EMS STATION RENOVATIONS**ADDENDUM NO. 2****EAST RALEIGH EMS STATION 7**

WAKE COUNTY REQUEST FOR BIDS NUMBER: RFB #26-082

DATE: **SEPTEMBER 10, 2026****BID DATE, TIME, AND LOCATION HAVE NOT BEEN CHANGED.**

1 ELECTRICAL NEW WORK
SCALE: 1/4" = 1'-0"

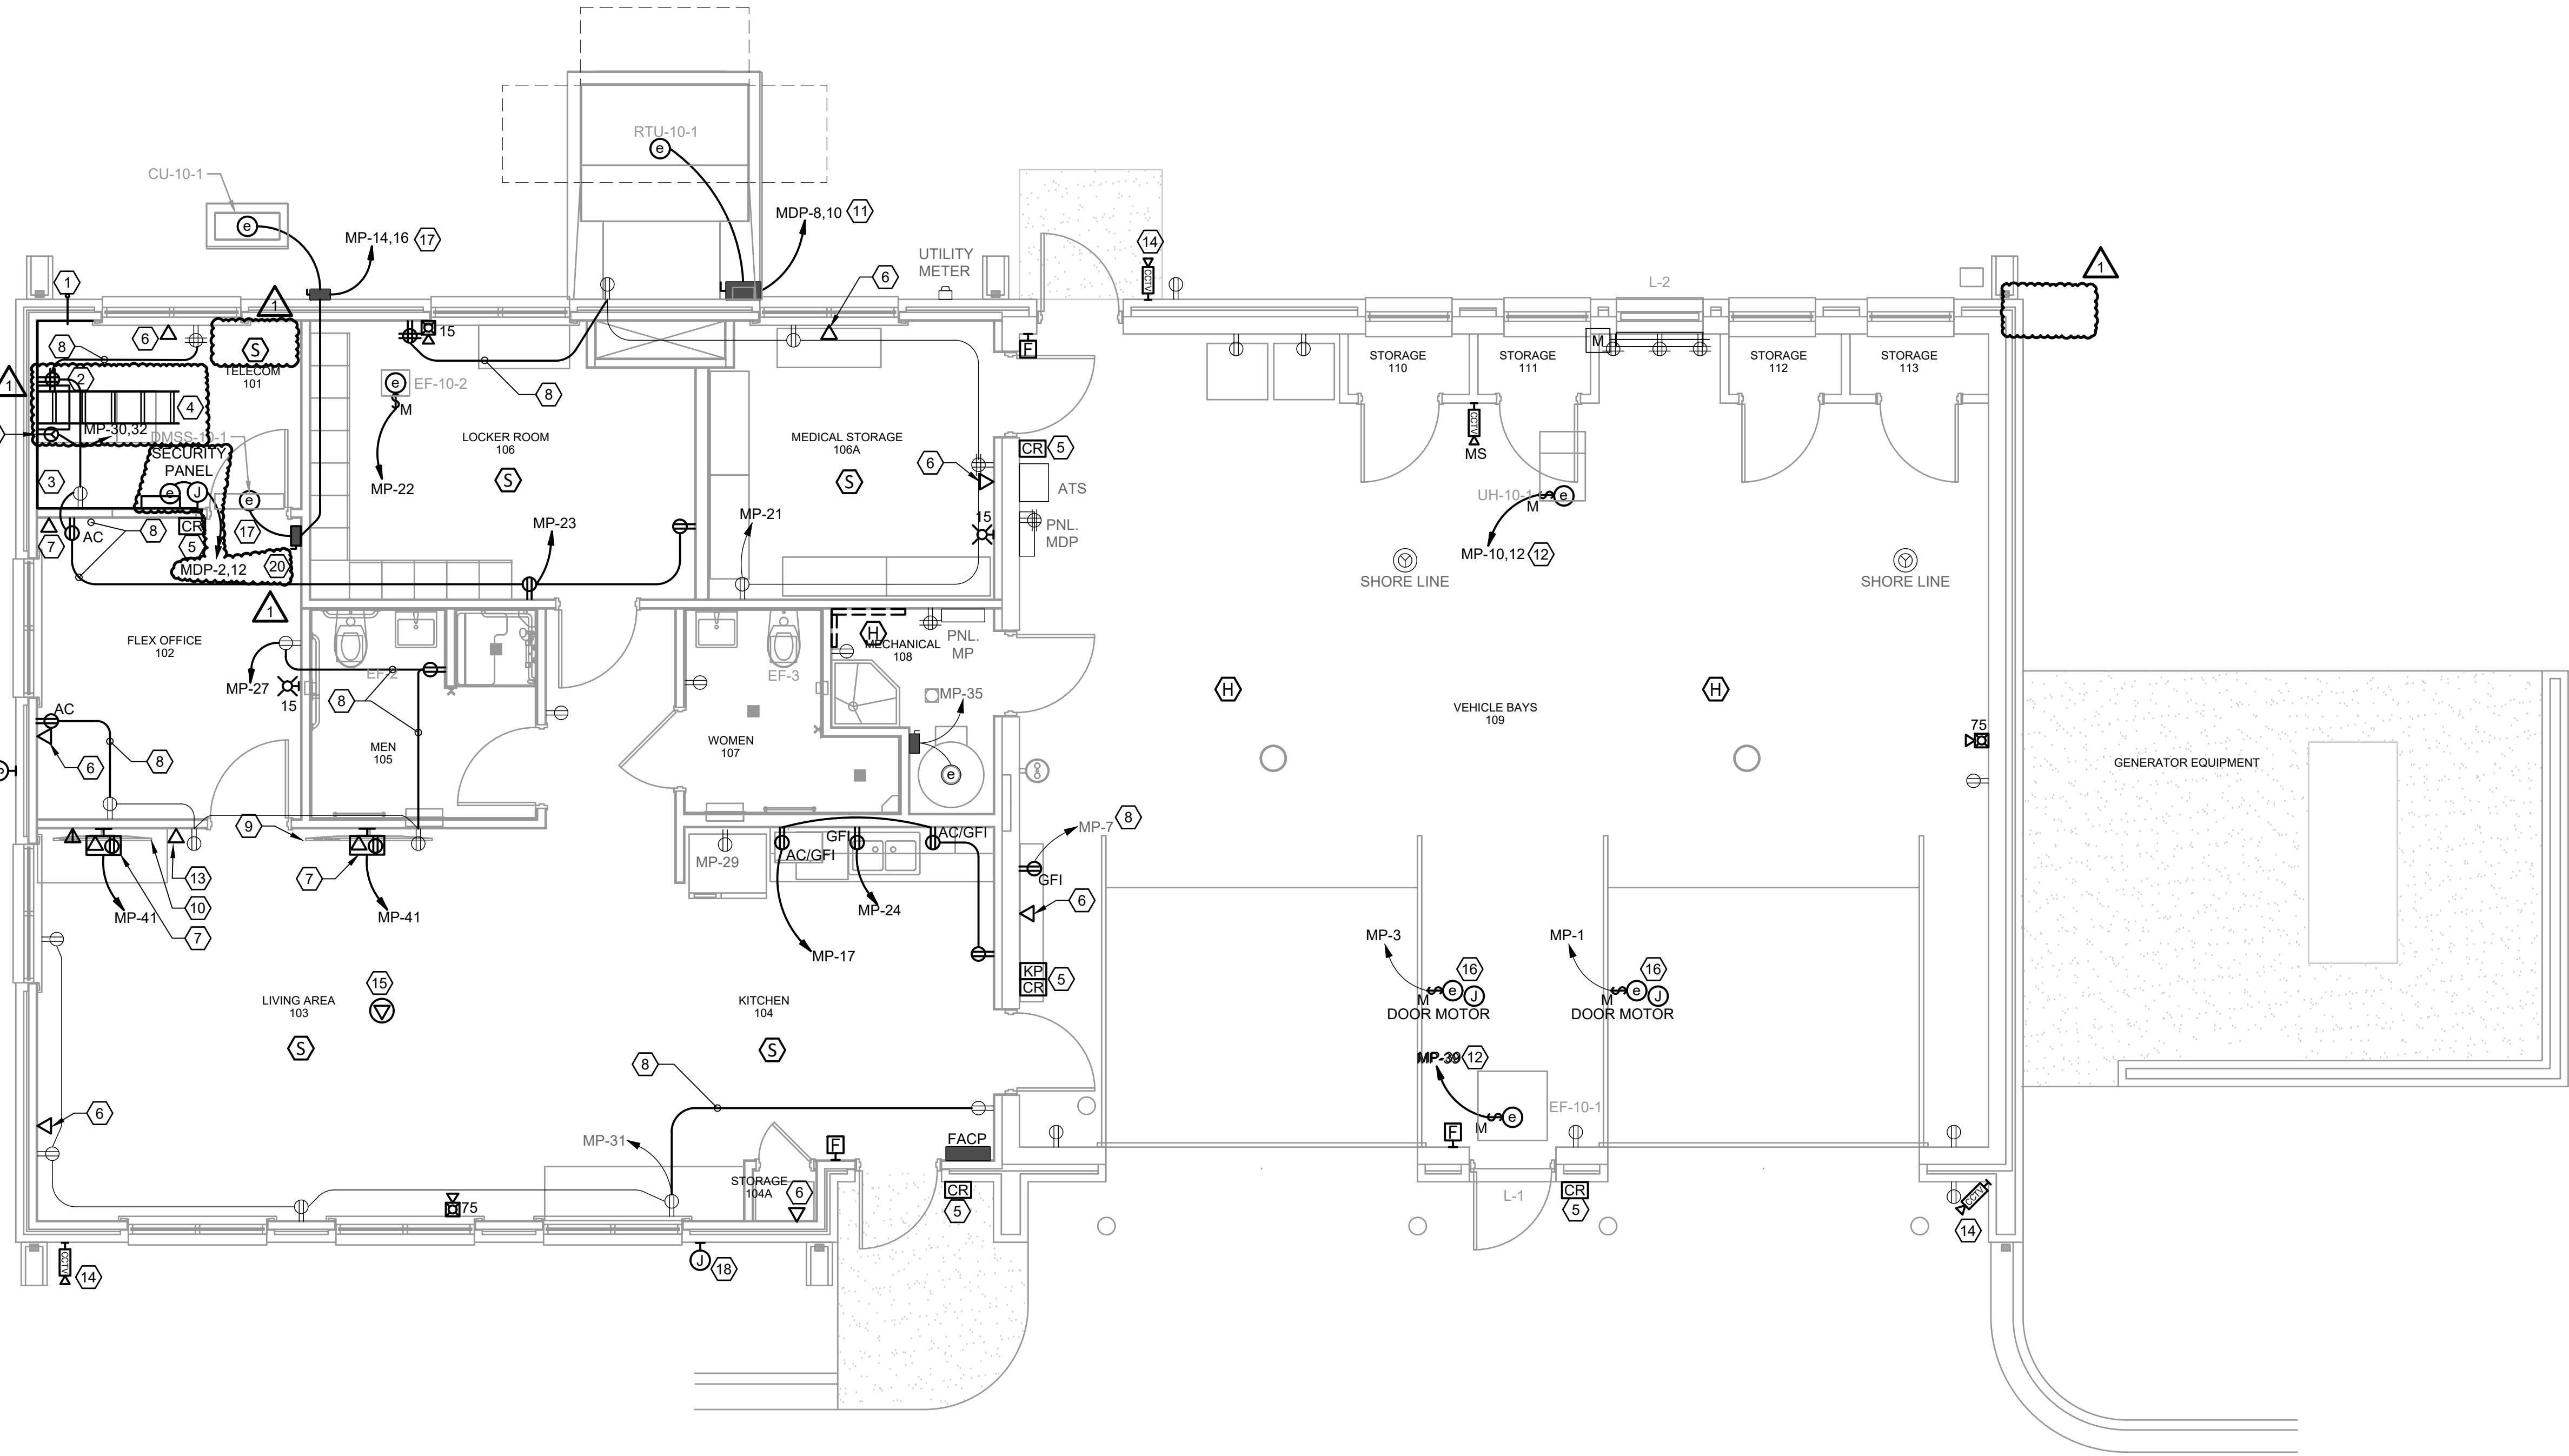
1. **REPLACE** Sheet 03-E111 – Electrical New Work with the attached, updated Sheet 03-E111 – Electrical New Work (Revision 1, Dated 09/10/26). Telecom 101 revisions. Camera at plan northeast corner of Vehicle Bays 109 deleted.

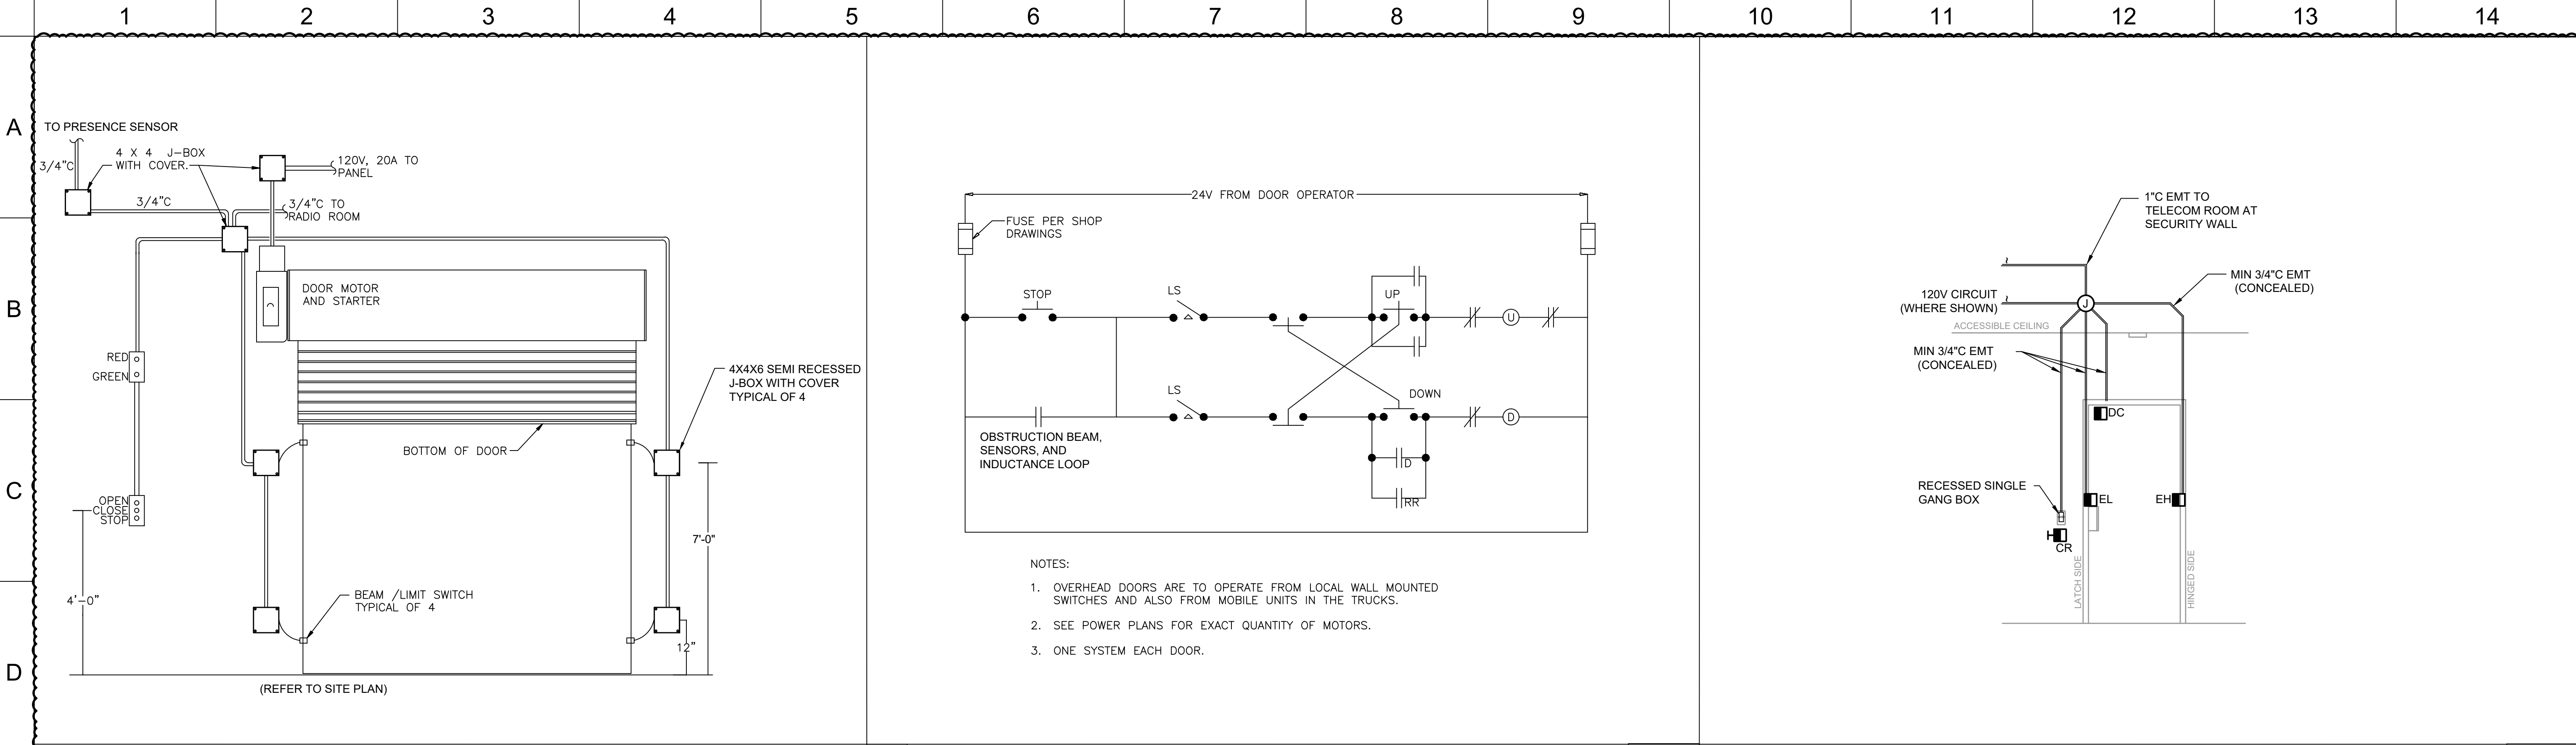
1. **REPLACE** Sheet 03-E503 – Details with the attached, updated Sheet 03-E503 – Details (Revision 1, Dated 09/10/26). Wall Mounted IDF detail deleted. Added details: Overhead Door Detail, Overhead Door Control Schematic, and Typical Card Access Door Rough-In Detail.
